Access Compliance Report

Public Rights-of-Way

(Curb Ramps)

Intersection ID: 10028581	Main Street: HOLYOKE_LN	Cross Street: N/A	Location: W
ADA ID: F4D3F1D504A6	Ramp Type: Perp	Initial Pass/Fail: Fail	Overall Compliance: No
Codes/Mitigation Info/Possible Solution		Field Measurements/Component Compliance	
		Severity Score: 25

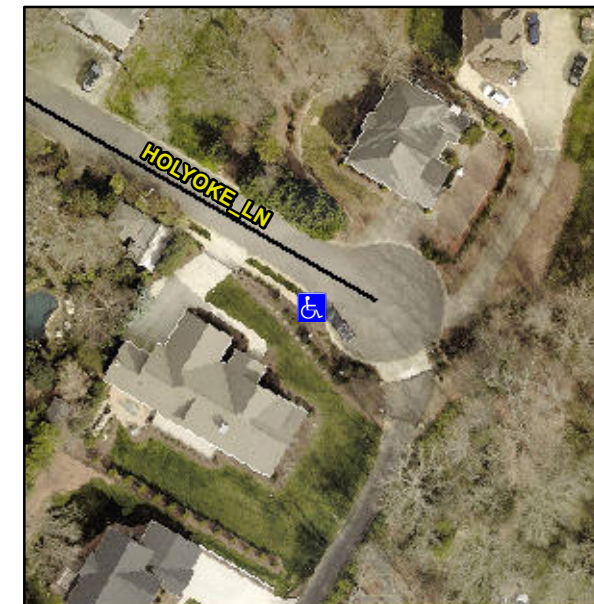
Not Found, R304.5.3

Compliance	Description	Data	Compliance	Description	Data
N/A	Ramp Length (in)	48.0	Yes	Ramp Slope (%)	8.3
Yes	Ramp Width (in)	48.0	No	Ramp XSlope (%)	8.5
N/A	Flare Type LT	N/A	N/A	Flare Type RT	N/A
N/A	Flare Slope LT (%)	N/A	N/A	Flare Slope RT (%)	N/A
N/A	Flare Traversable LT?	N/A	N/A	Flare Traversable RT?	N/A
N/A	Landing Length (in)	N/A	N/A	DWS Provided?	N/A
N/A	Landing Width (in)	N/A	N/A	DWS Contrast?	N/A
N/A	Landing Slope (%)	N/A	N/A	DWS Length (in)	N/A
N/A	Landing X Slope (%)	N/A	N/A	DWS Full Width?	N/A
N/A	Landing Curb? (Y/N)	N/A	N/A	DWS Offset (in)	N/A
N/A	Shared Landing?	N/A			
N/A	Gutter Ponding?	N/A	N/A	Gutter Slope (%)	N/A
N/A	Gutter Lip Ht (in)	N/A	N/A	Gutter X Slope (%)	N/A
N/A	Painted X Walk1?	No	N/A	Painted X Walk2?	N/A
	X Walk 1 Direction	To E		X Walk 2 Direction	N/A
N/A	X Walk 1 Width (in)	N/A	N/A	X Walk 2 Width (in)	N/A
	X Walk 1 Slope (%)	4.3		X Walk 2 Slope (%)	N/A
	X Walk 1 X Slope (%)	8.2		X Walk 2 X Slope (%)	N/A

Remove & Replace Entire Ramp.
